**TECHNICAL BULLETIN****[ 1 / 4 ]**

[Issue No.] FA-A-0186

[Title] Improvements in CC-Link IE Field Network specifications for momentary data link error in all the stations

[Relevant Models] RJ71GF11-T2, RJ71EN71, QJ71GF11-T2, LJ71GF11-T2,  
Q81BD-J71GF11-T2, Q80BD-J71GF11-T2

Example: When the actual network configuration is changed from line topology to coexistence of star topology and line topology

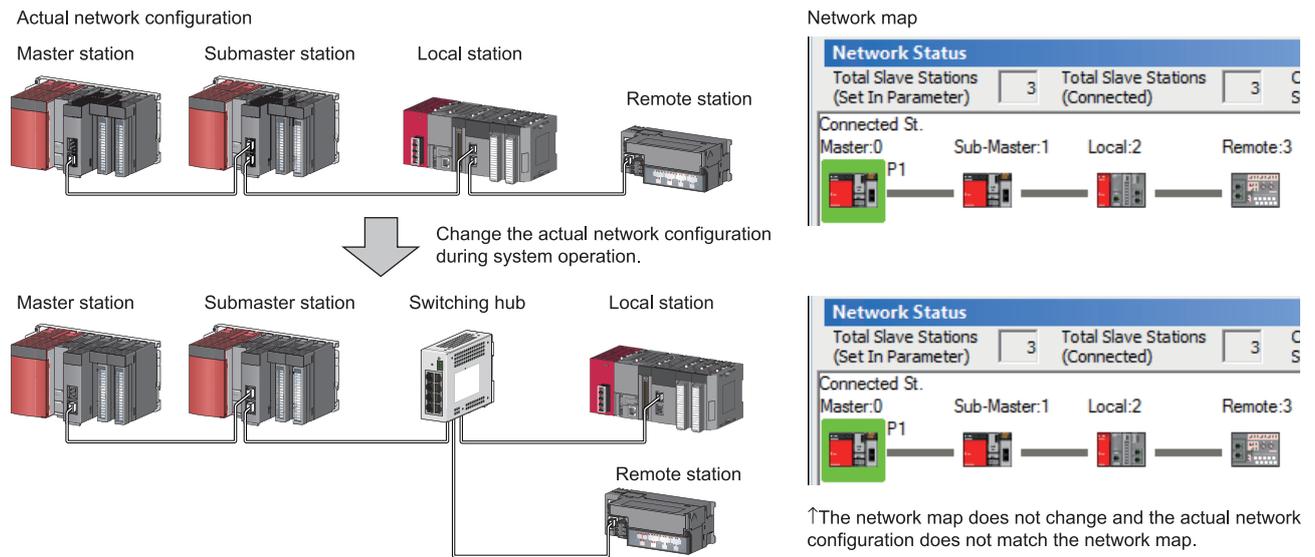
With the improvements in specifications, when operation described in "2. Description" is performed, the actual network configuration and the network map of the CC-Link IE Field Network diagnostics may be a mismatch.

**3.1 How to check whether the actual network configuration and the network map are a mismatch or not**

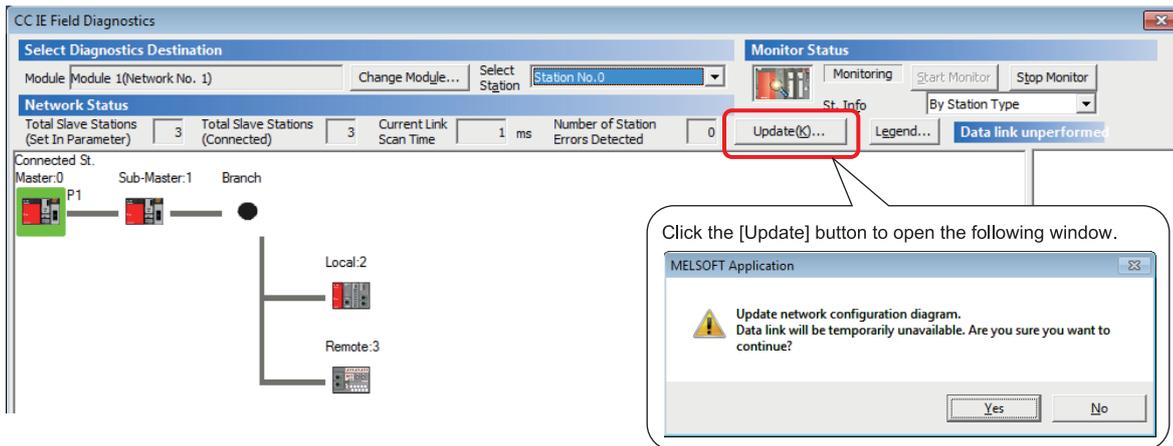
Whether mismatch is occurred or not can be checked using Network configuration mismatch occurrence status (SB0098) or "Selected Station Communication Status Monitor" in CC-Link IE Field Network diagnostics of the master station.
